**Subject:** Mod2019-0477 (DA2017-1294)

Mod2019/0477 – DA2017/1294  
9-15 Lawrence Street FRESHWATER

Re Pedestrian Link

Strata Plan S P 1172 Registered: 21-1-1976

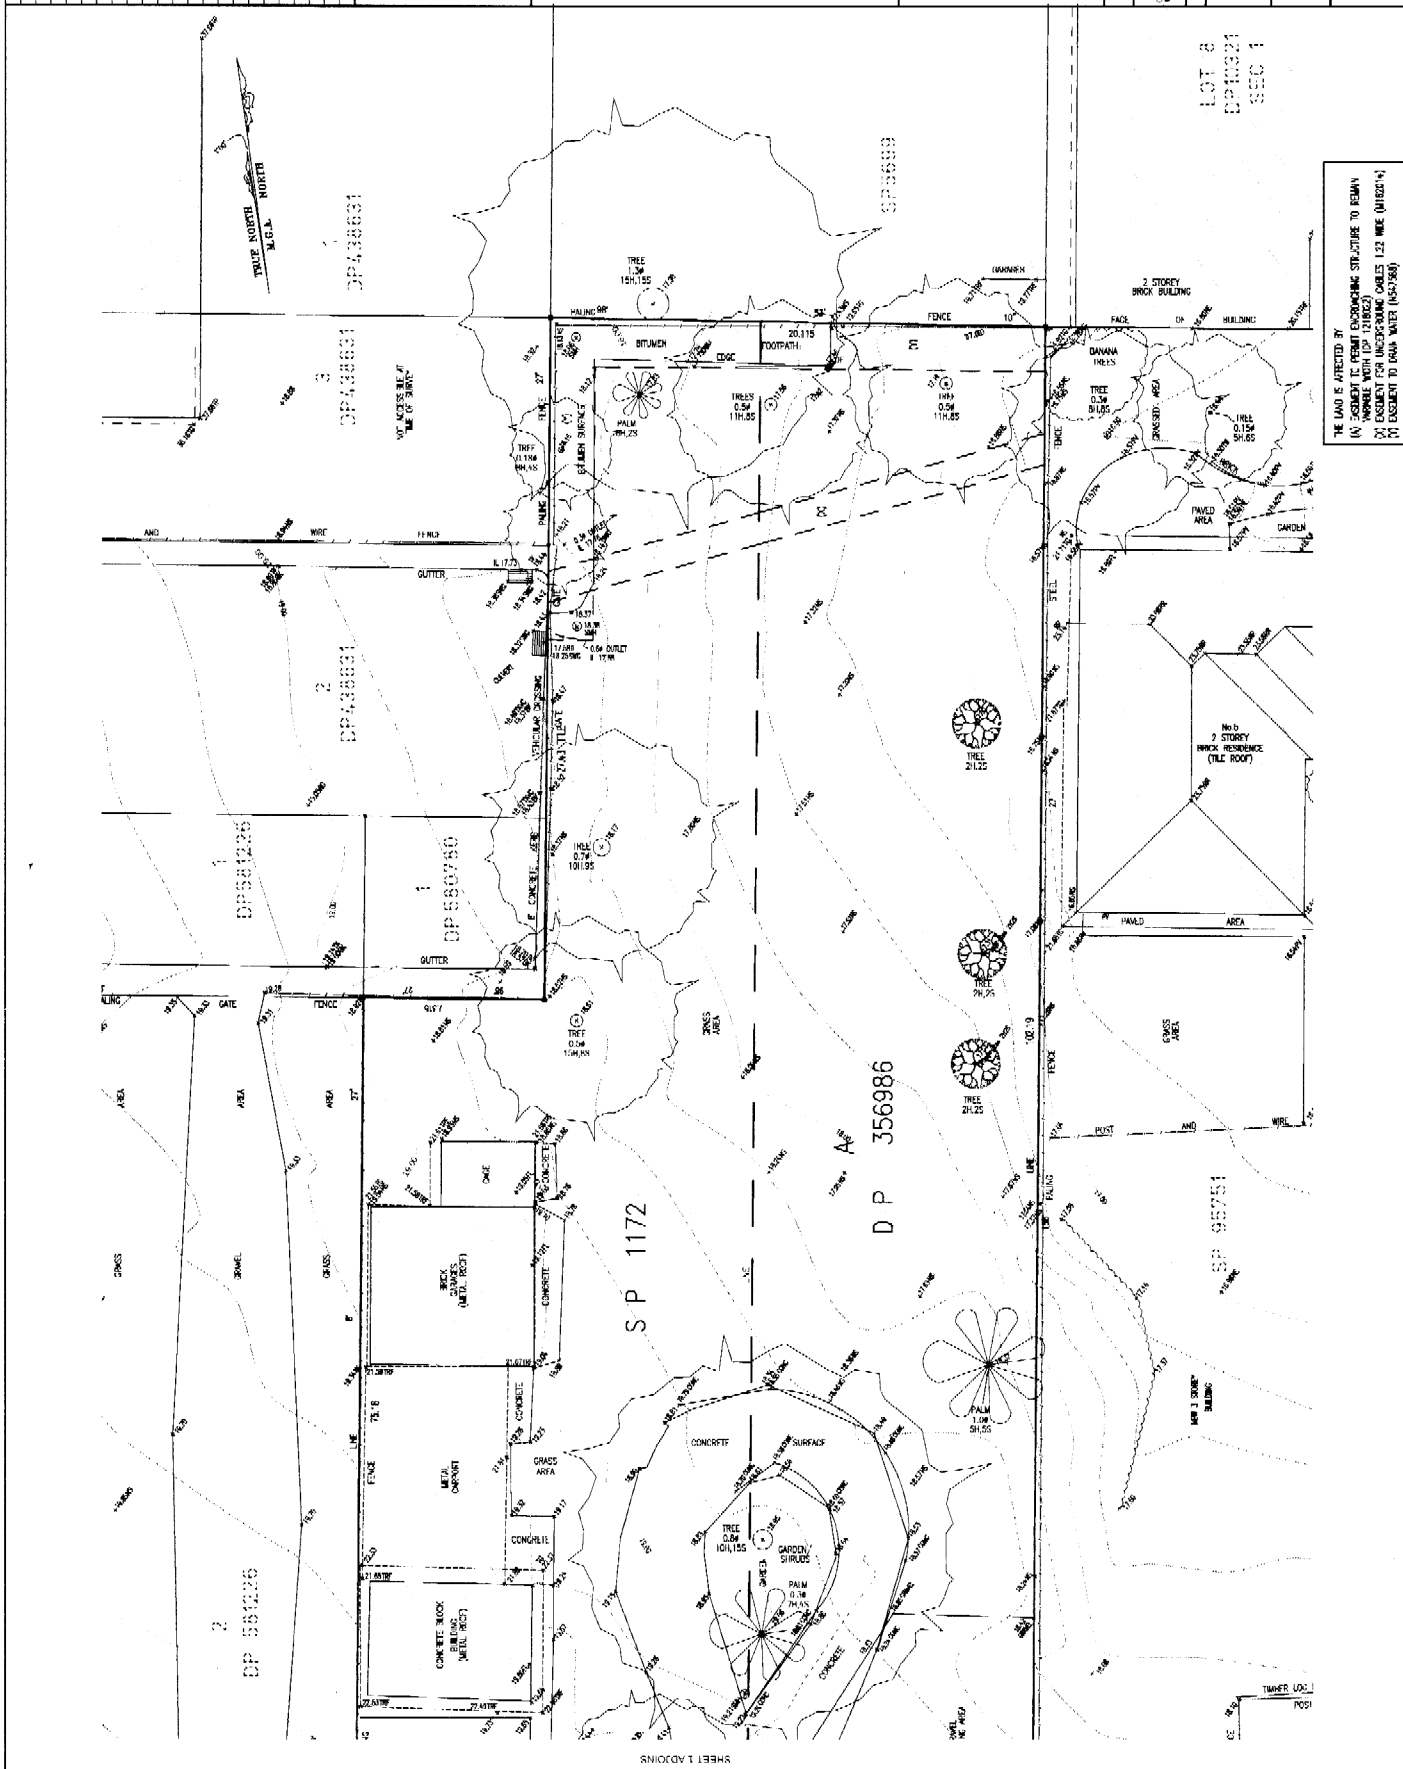
NB The reference to ‘BITUMEN SURFACE’ and ‘BITUMEN FOOTPATH’ above the drainage easement. The bitumen footpath was used to access the church hall.

Easement to Drain Water is 1.83m wide within Lot 2

Diagram (inset) in survey plan shows Easement to Drain Water in S P 1172 and Lot A DP 356986.

of Site of Proposed Easement for Drainage through Por. 381 & Lot 8 in D.P. 10321

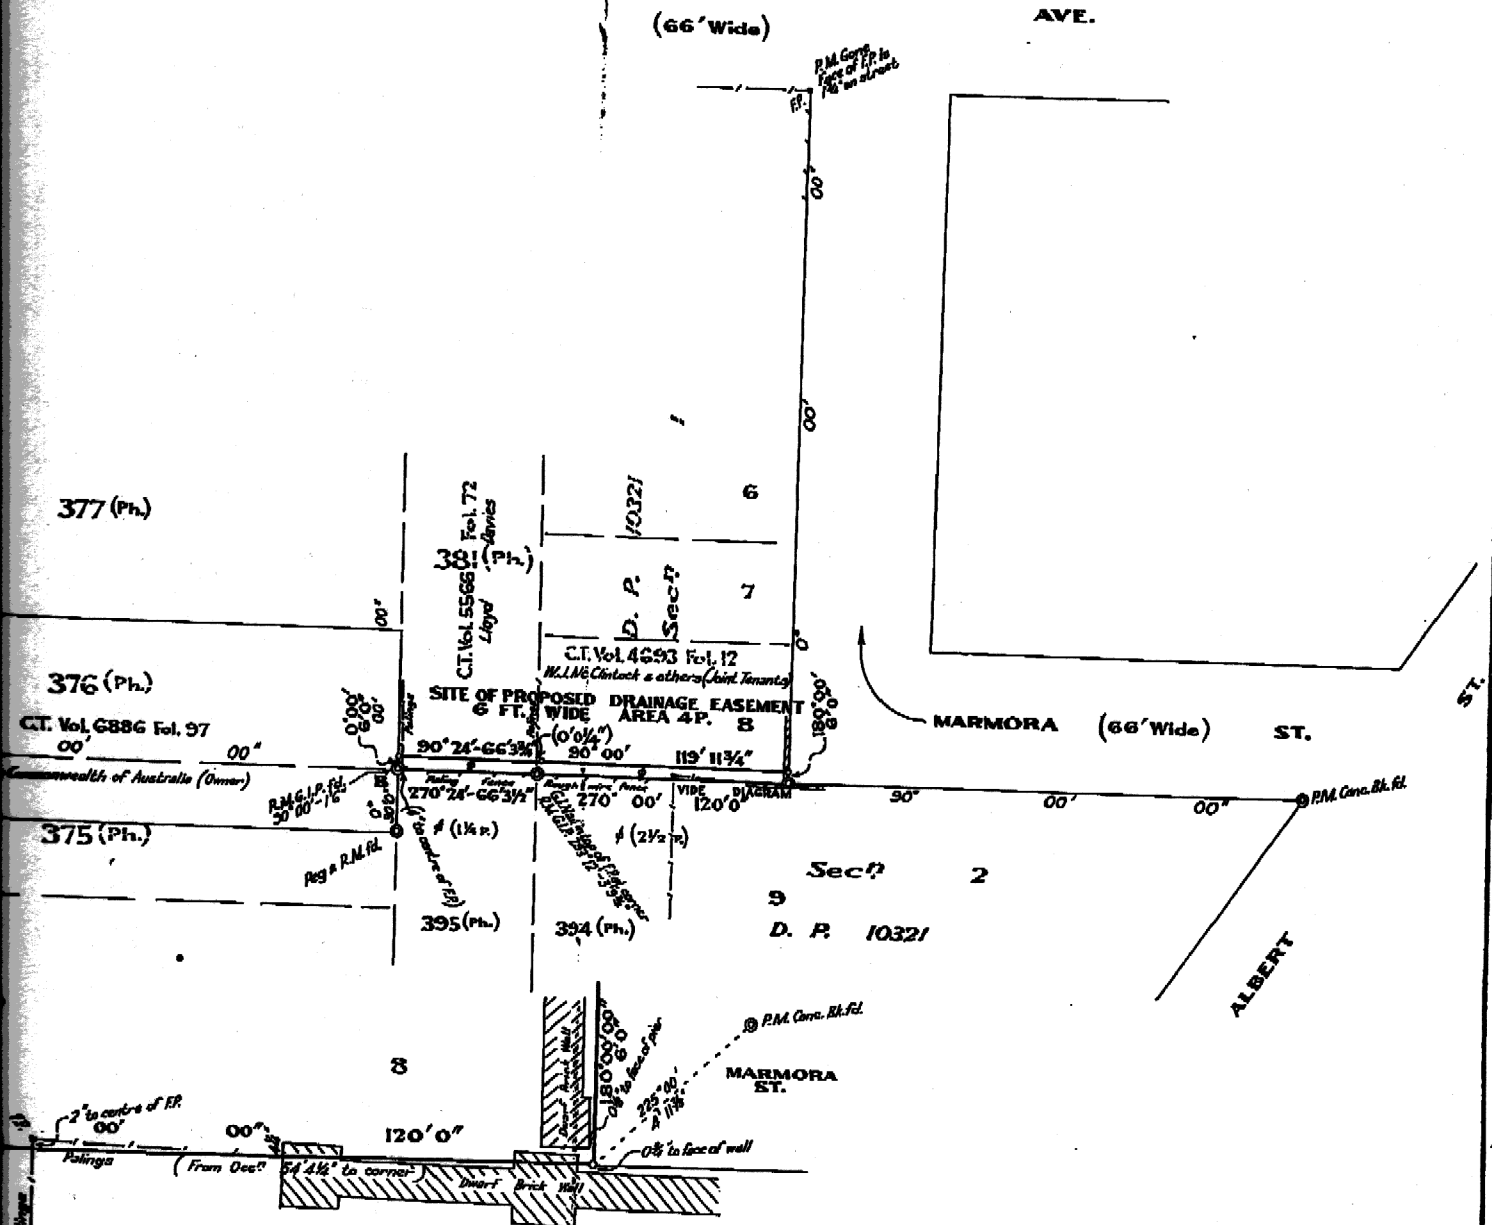
The 1985 Zoning Map identifies an easement between the Telecommunications (Telstra) site and Marmora Street. (See attached Map.) The E-W easement is shown as a separate parcel of land. It has a corridor width of 6ft and adjoins the southern boundary of the two intervening lots, including the Church land, which is 66 ft wide (N-S) and 120 ft long (E-W).

Number above easement: 441897
